# Planning & Community Development Dept. Review

## REVIEW ROUND 3

Project: 2400 S. Arlington Heights Rd.  
Paragon Mechanical LUV

Case Number: PC 20-004

## ALTA / NSPS LAND TITLE SURVEY

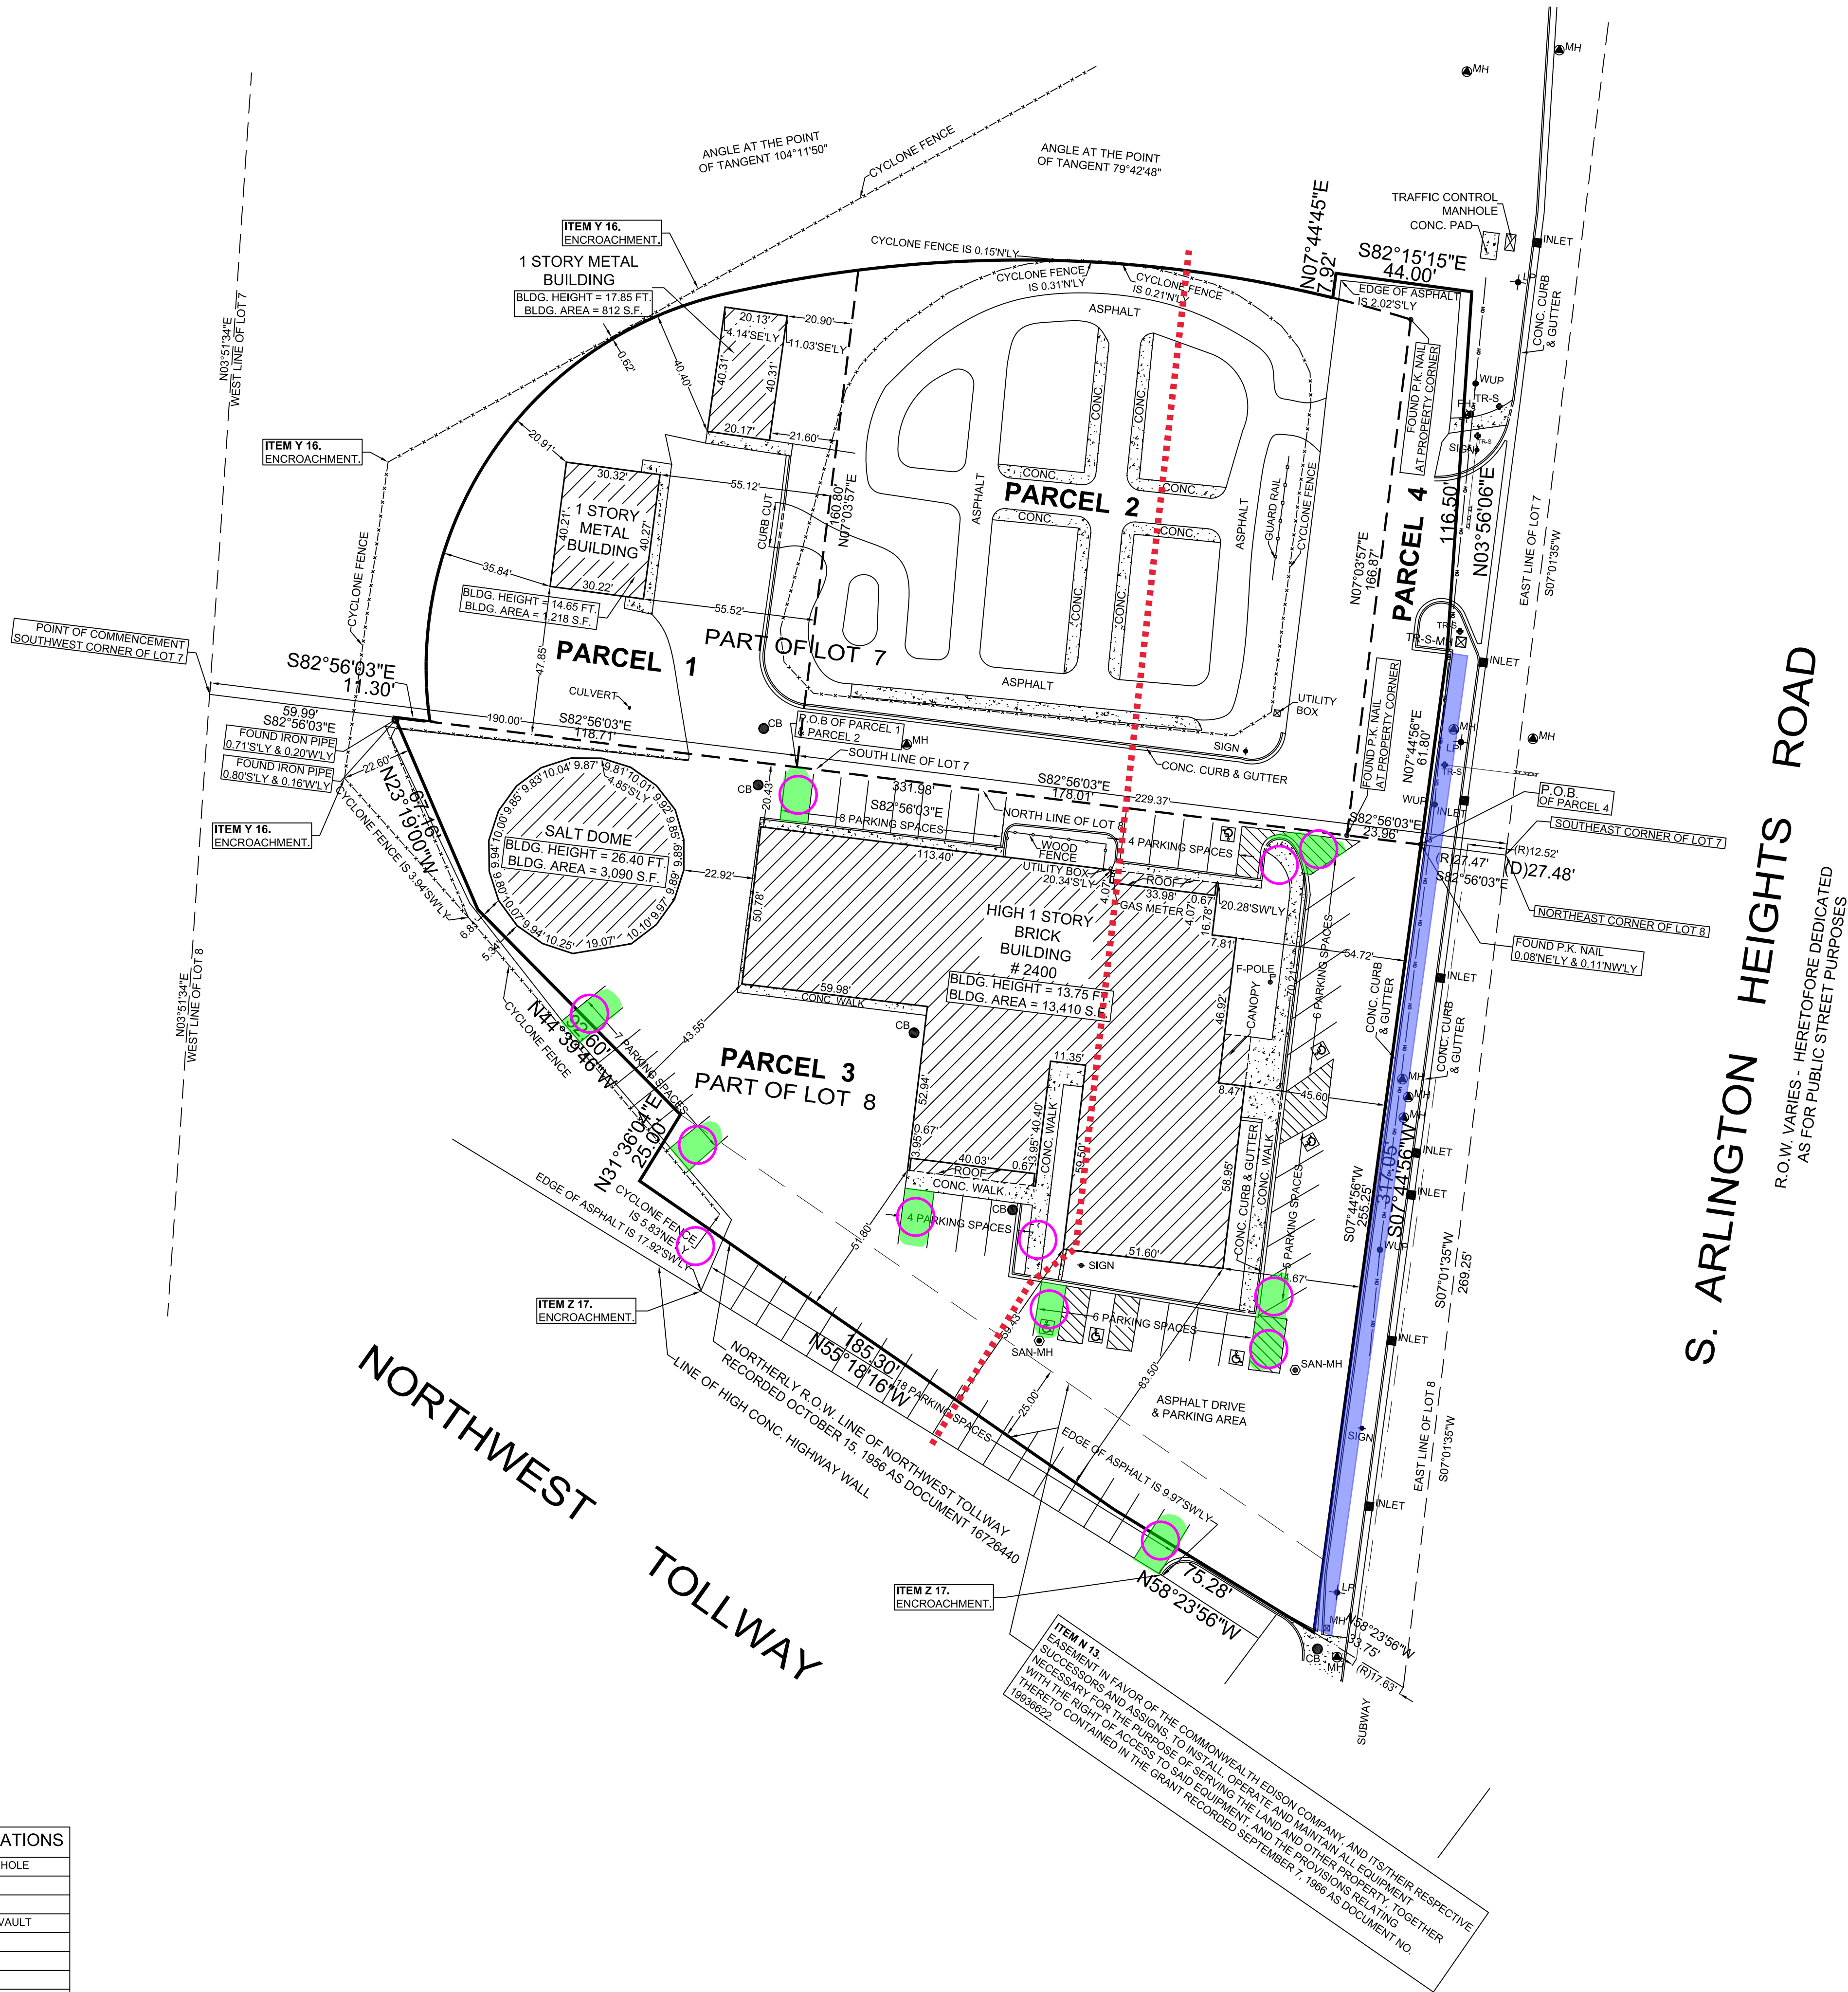
3' Tall Parking Lot Landscape Screen

Landscape Island

4" Caliper Shade Tree

Phase I/Phase II delineation. Improvements to the east of this line must be installed no later than September 30, 2020. Items to the west of this line must be installed no later than September 30, 2022.

1. The responses to comments 1-3 are noted. Should a phased approach be acceptable by the Plan Commission or Village Board, staff has prepared an alternative phasing plan. Per this alternative phasing plan, all Phase 1 landscaping must be completed by September 30, 2020 and Phase 2 landscaping must be completed by September 30, 2022.
